Google Maps 899 8th St SW

Albuquerque, New Mexico

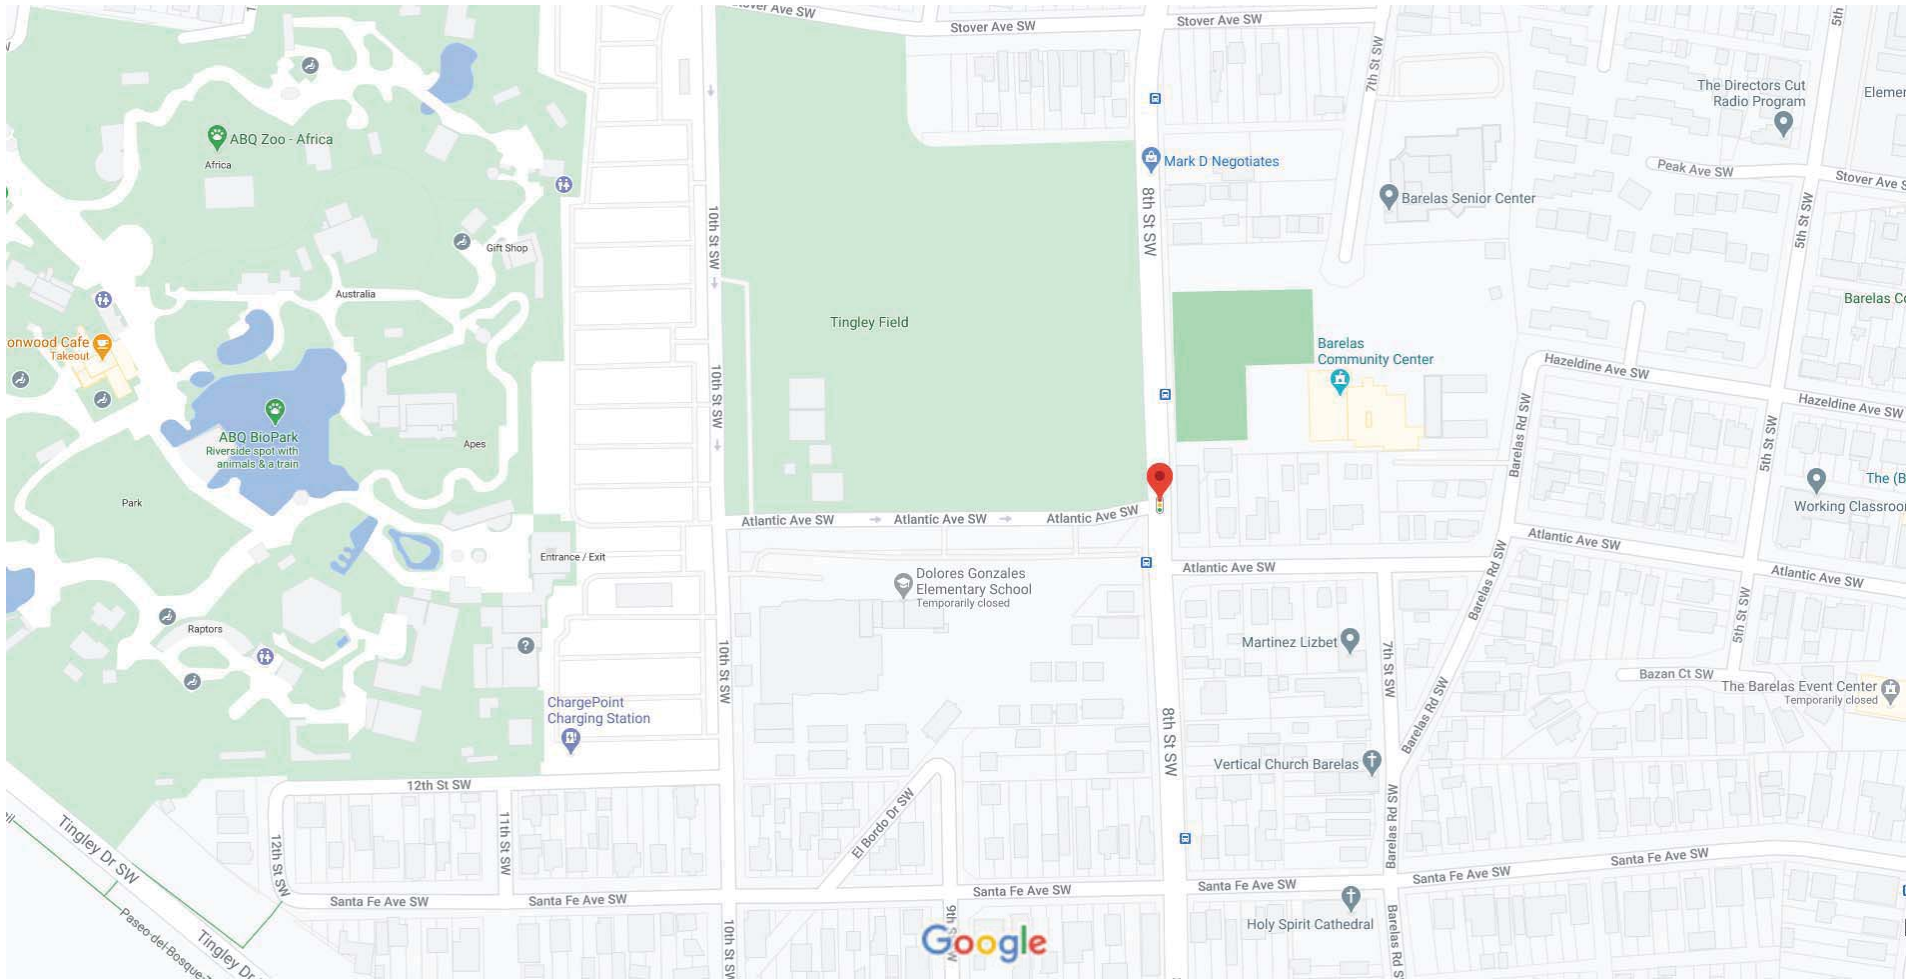
I made a sight visit and I believe that eliminating all header curb would be beneficial while still not allowing water onto the property. Back driveway pad would be 6' deep with approx 14% slope while maintaining a 5' ADA compliant walkway. As it sits, it's a 21% slope in 2' and both ramps are not ADA compliant. No survey needed.
